CALIFORNIA COASTAL COMMISSION

December 21, 2000

**SUBJECT: STAFF RECOMMENDATION ON CITY OF SAN DIEGO MAJOR LOCAL
COASTAL PROGRAM AMENDMENT #4-2000 (CENTRE CITY—NORTH
EMBARCADERO OVERLAY DISTRICT)**

Proposed
Building Height-North Embarcadero

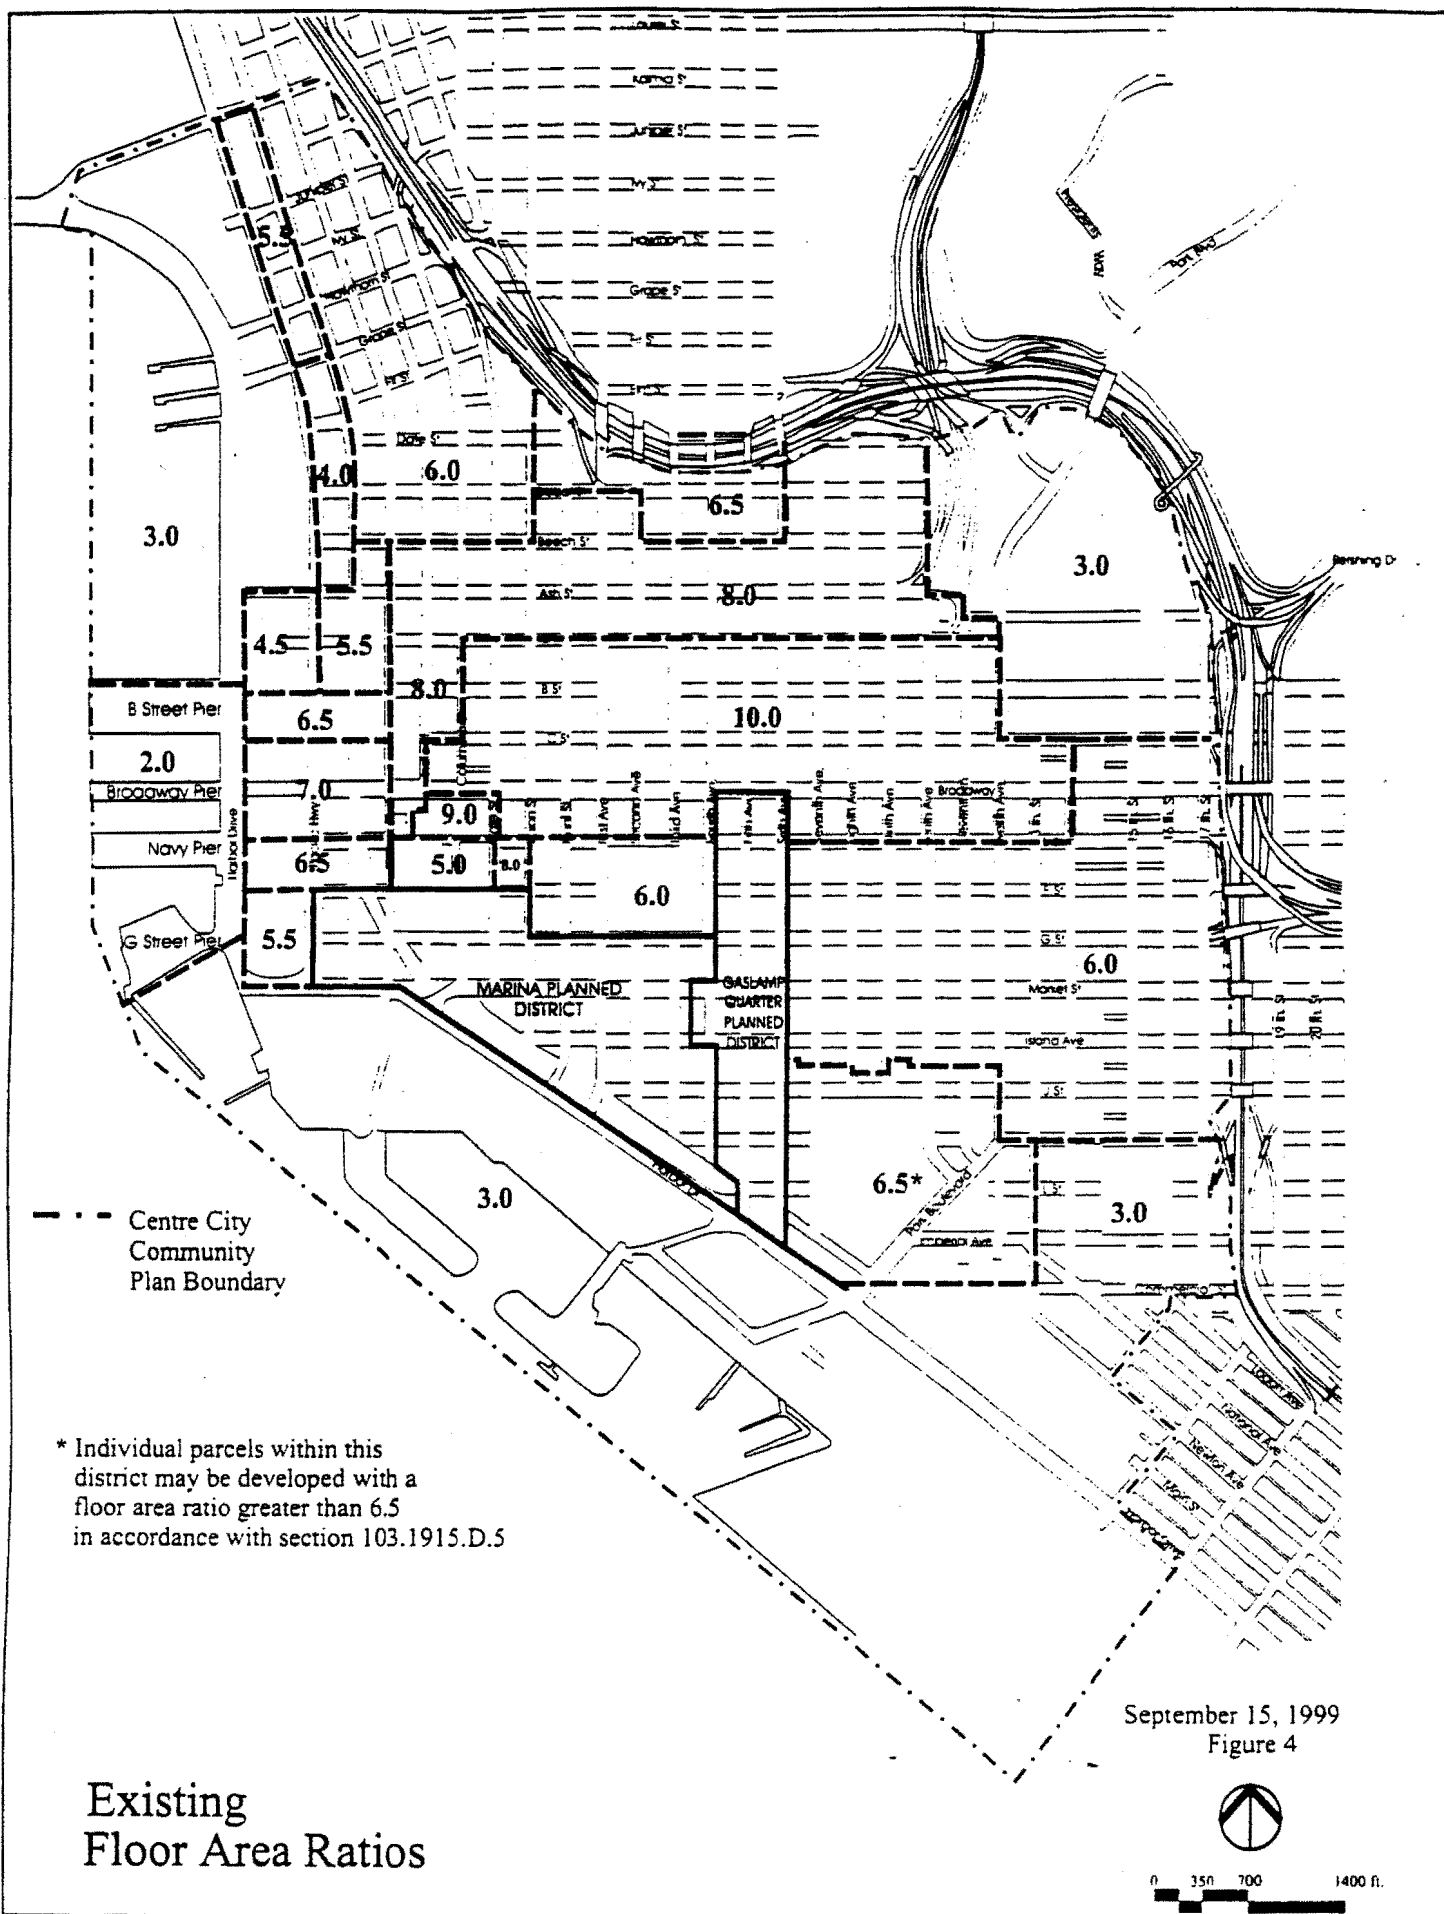
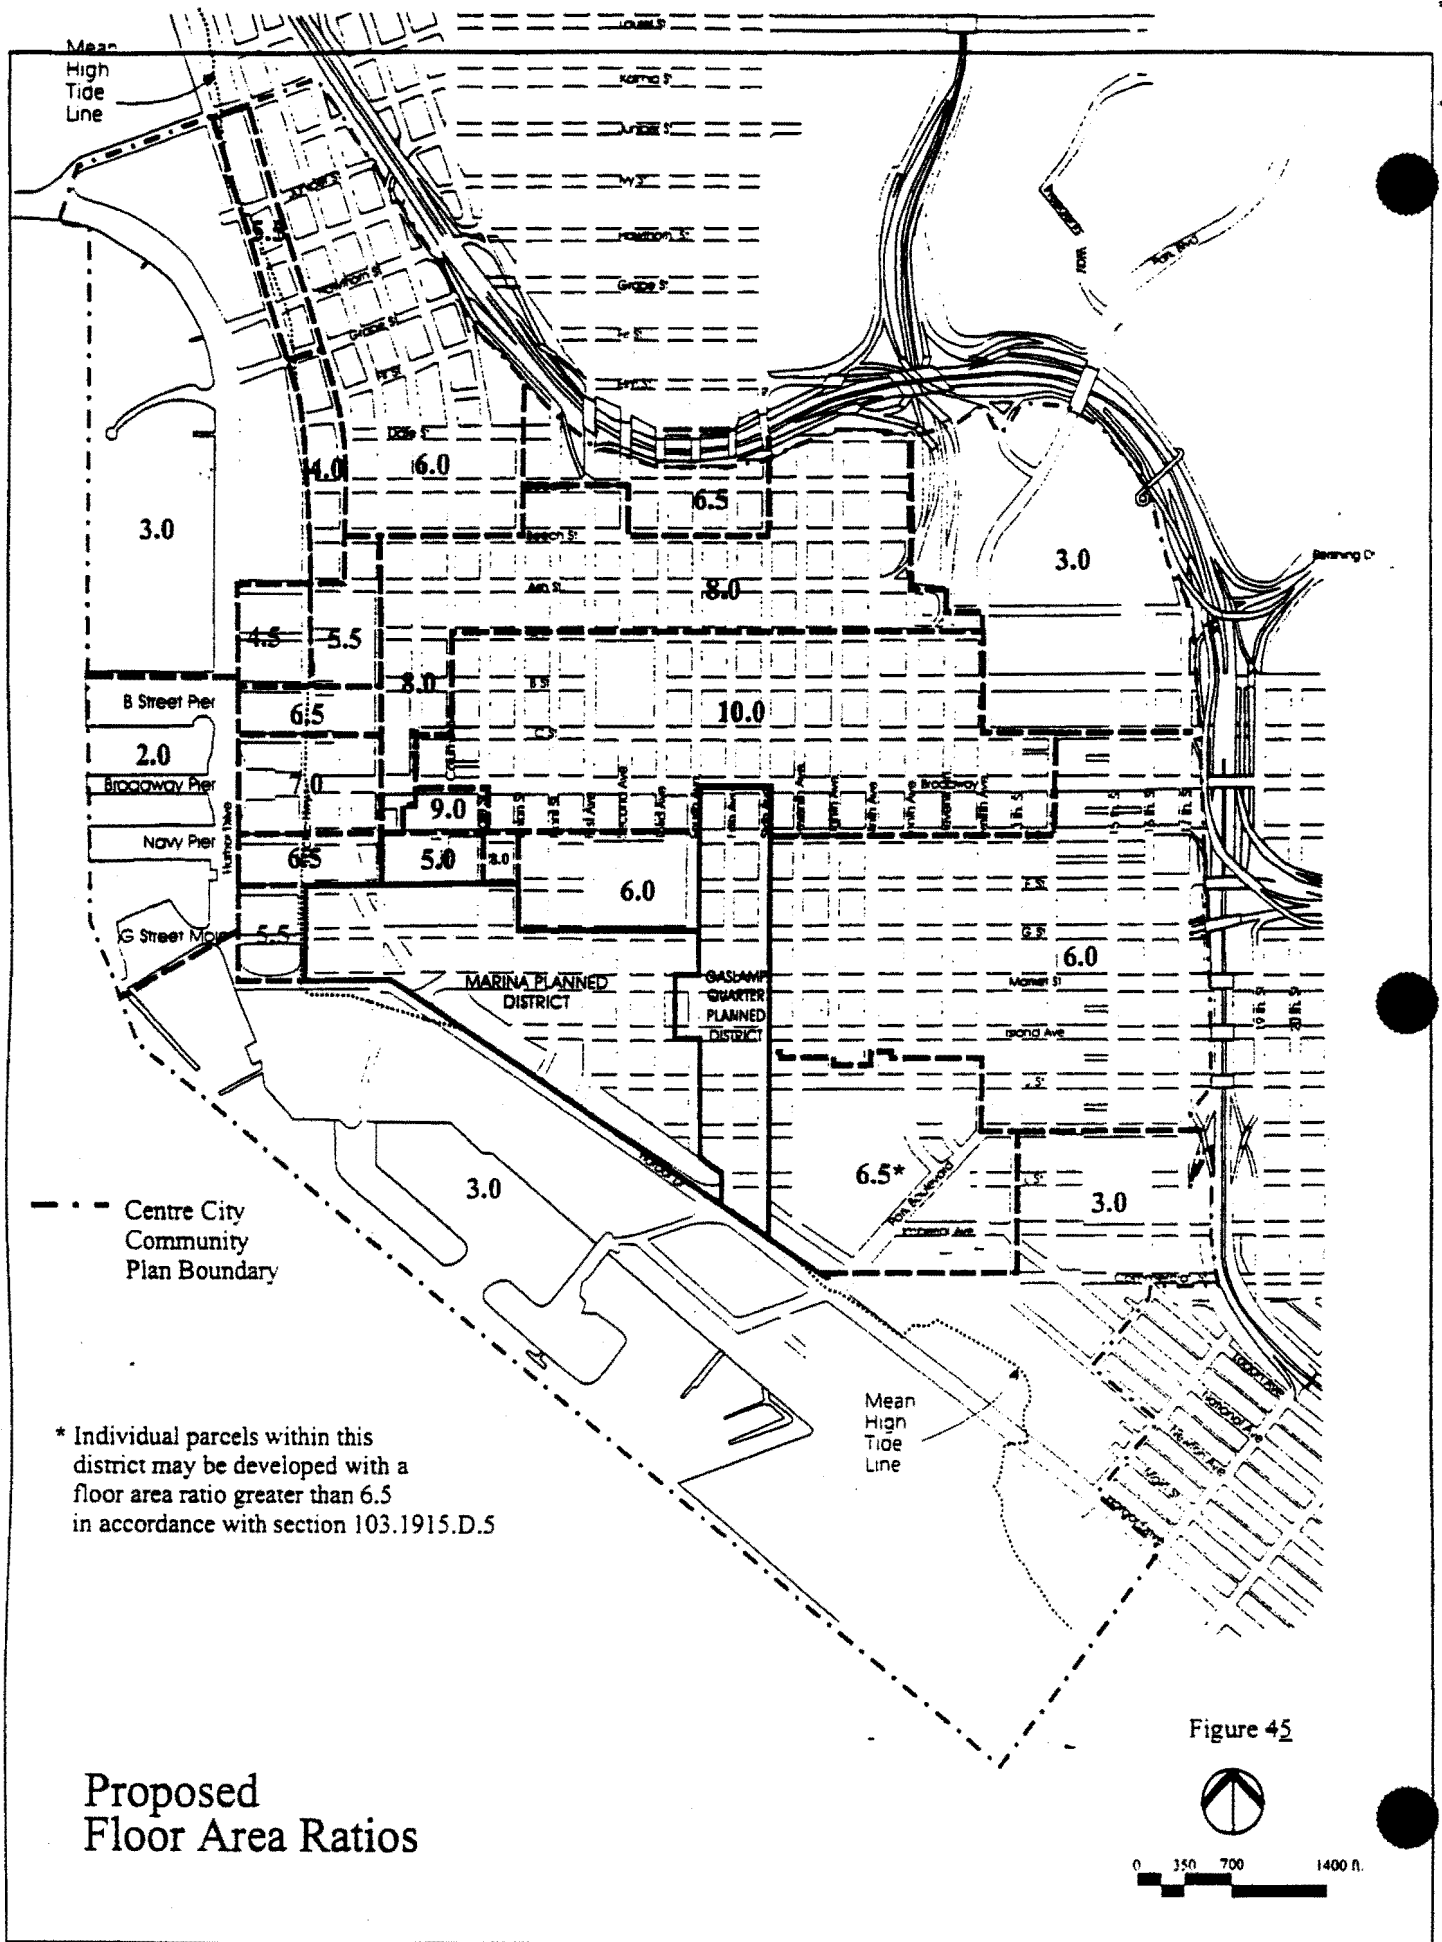
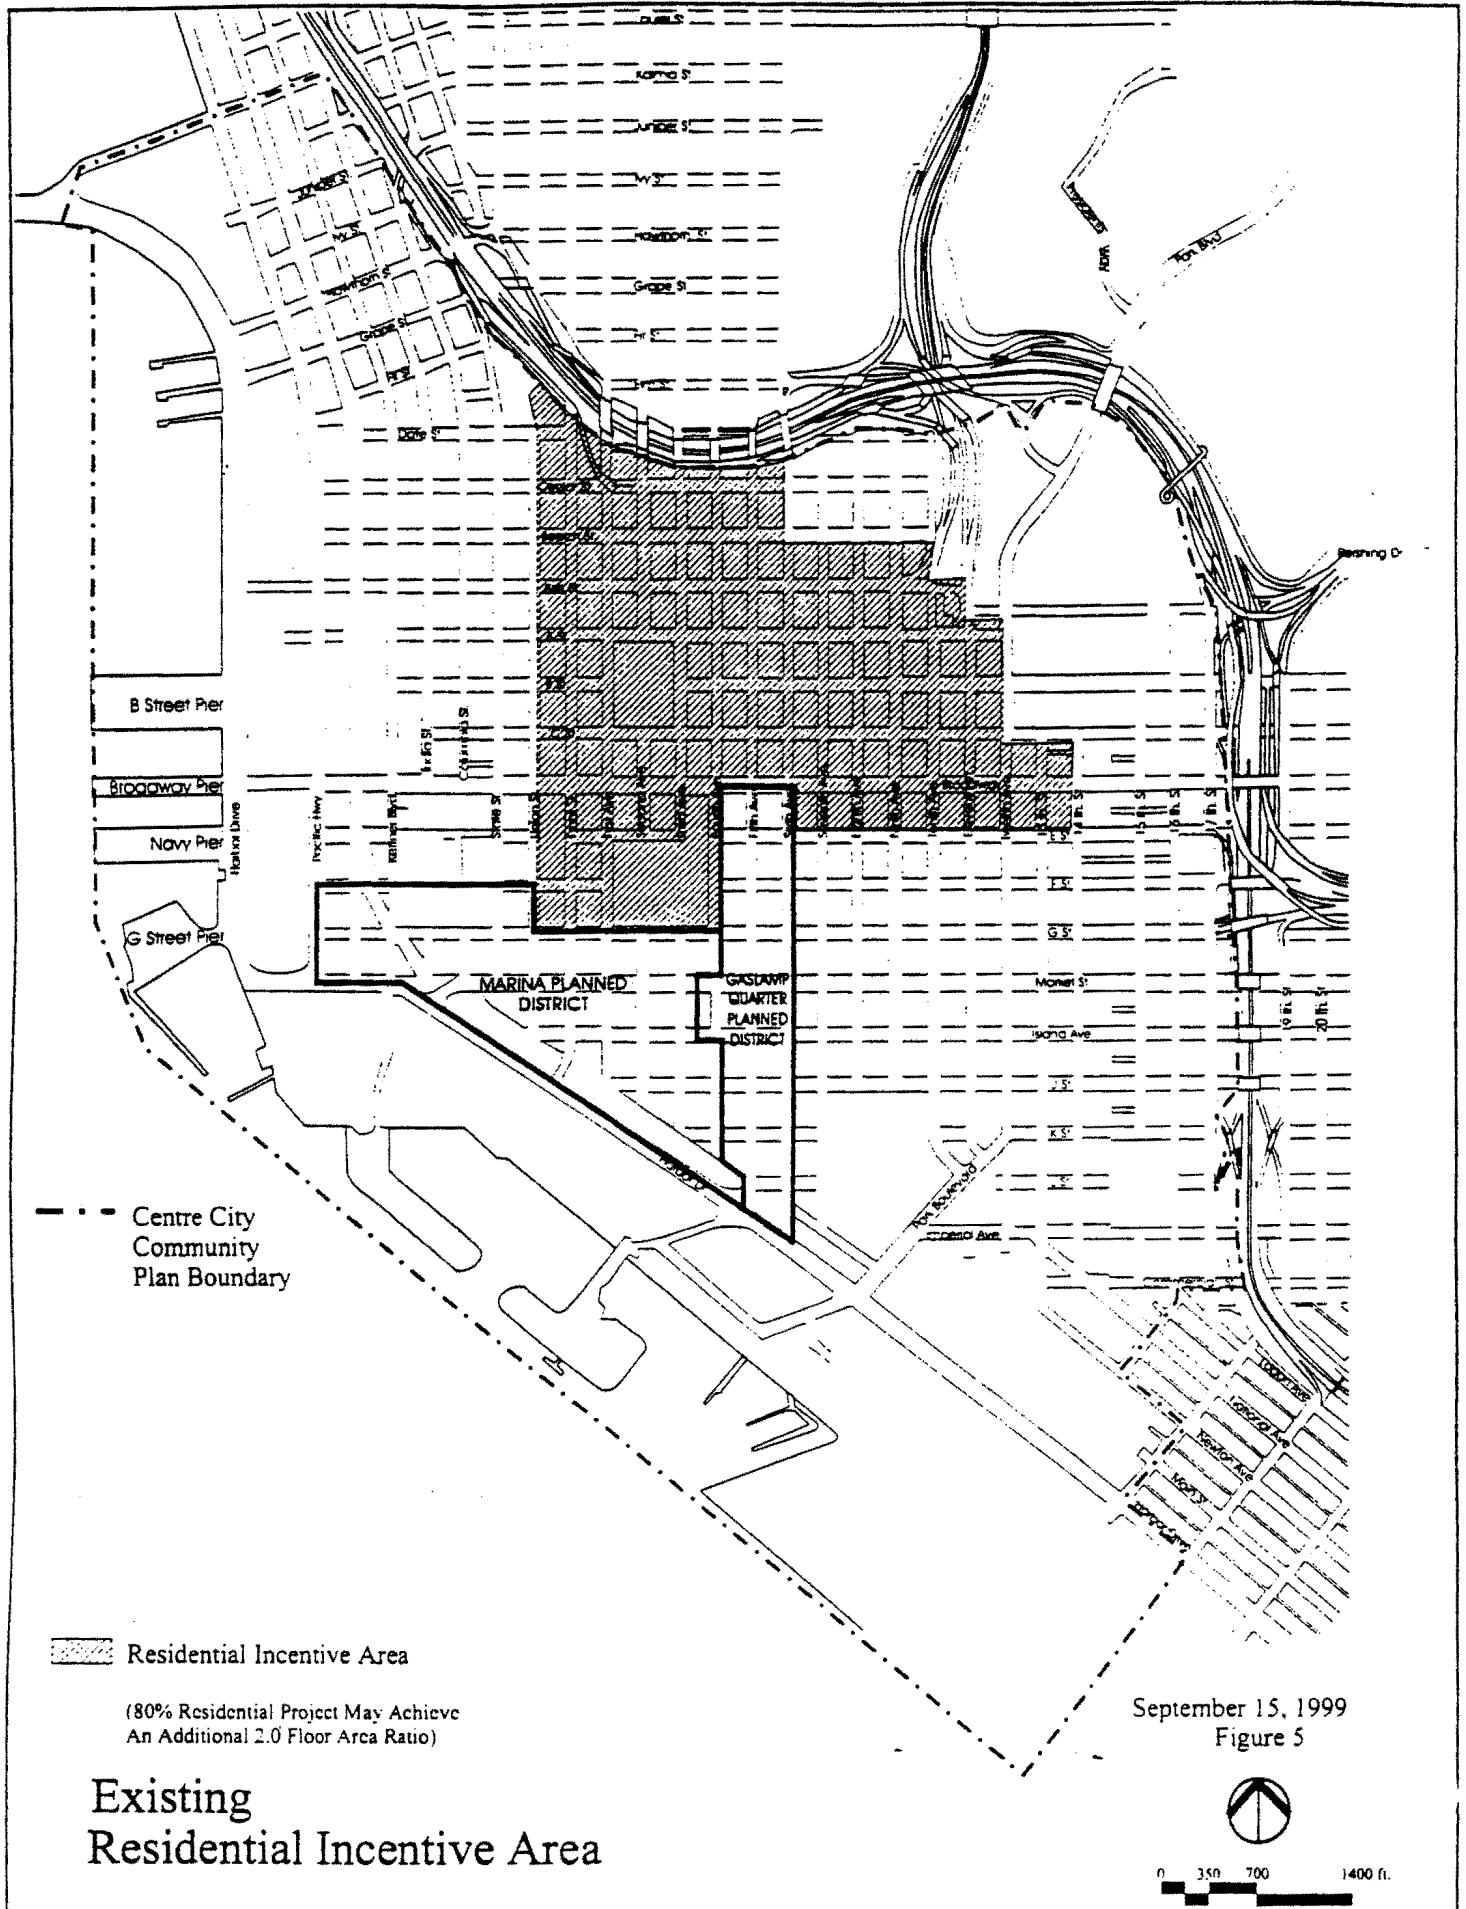
The amendment would add a new Building Height-North Embarcadero as Figure 4 to the PDO. The figure includes proposed height maximums for the North Embarcadero. However, as proposed, the figure is not entirely consistent with the proposed heights contained in the proposed PMPA #27 for the area within the Port's jurisdiction. To resolve the inconsistency, the City has agreed it would be appropriate to remove the proposed height designations from all of the locations that are not within the City's coastal permit jurisdiction.

As discussed above, the proposed new Figure 4, Building Height-North Embarcadero, includes height limits for areas within the Port District's permit jurisdiction. However, as proposed, the figure is not entirely consistent with the proposed heights contained in the proposed PMPA #27. To resolve the inconsistency, the City has agreed that it would be appropriate to remove the proposed height designations from all of the locations that are not within the City's coastal permit jurisdiction. Therefore, Suggested Modification #7 removes all of the height designations from the proposed Figure 4 west of Pacific Highway.

7. The proposed Figure 4, **Building Height-North Embarcadero**, shall be revised as follows:

The figure shall be revised to eliminate any height limits on lands not within the City of San Diego's coastal permit jurisdiction; that is, any area west of Pacific Highway.
